## Access Compliance Report Public Rights-of-Way (Curb Ramps)

Intersection ID: 44449 Main Street: BAYVIEW\_PY Cross Street: PRESTBURY\_BV Location: E

ADA ID: A4E45B1DAE7B Ramp Type: BlendTrans1 Initial Pass/Fail: Fail Overall Compliance: No Severity Score: 8.75

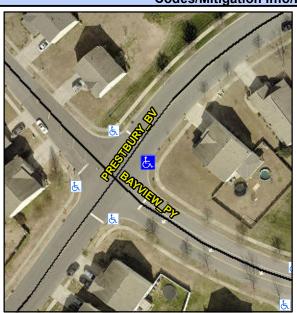
Not Found, R304.5.1

Field Measurements/Component Compliance						
	Compliance Description		Data	Compliance Description		Data
	N/A	Ramp Length (in)	74.0	Yes	BlendTrans Slope (%)	2.5
	No	Ramp Width (in)	36.0	Yes	BlendTrans XSlope (%)	0.4
	N/A	Flare Type LT	N/A	N/A	Flare Type RT	N/A
	N/A	Flare Slope LT (%)	N/A	N/A	Flare Slope RT (%)	N/A
	N/A	Flare Traversable LT?	N/A	N/A	Flare Traversable RT?	N/A
	N/A	Landing Length (in)	N/A	N/A	DWS Provided?	N/A
	N/A	Landing Width (in)	N/A	N/A	DWS Contrast?	N/A
	N/A	Landing Slope (%)	N/A	N/A	DWS Length (in)	N/A
	N/A	Landing X Slope (%)	N/A	N/A	DWS Full Width?	N/A
	N/A	Landing Curb? (Y/N)	N/A	N/A	DWS Offset (in)	N/A
	N/A	Shared Landing?	N/A			
	N/A	Gutter Ponding?	N/A	N/A	Gutter Slope (%)	N/A
	N/A	Gutter Lip Ht (in)	N/A	N/A	Gutter X Slope (%)	N/A
	N/A	Painted X Walk1?	No	N/A	Painted X Walk2?	No
		X Walk 1 Direction	To NW		X Walk 2 Direction	To SW
		X Walk 1 Width (in)	N/A		X Walk 2 Width (in)	N/A

Remove & Replace Curb Ramp With Two New Directional Ramps or Equivalent.
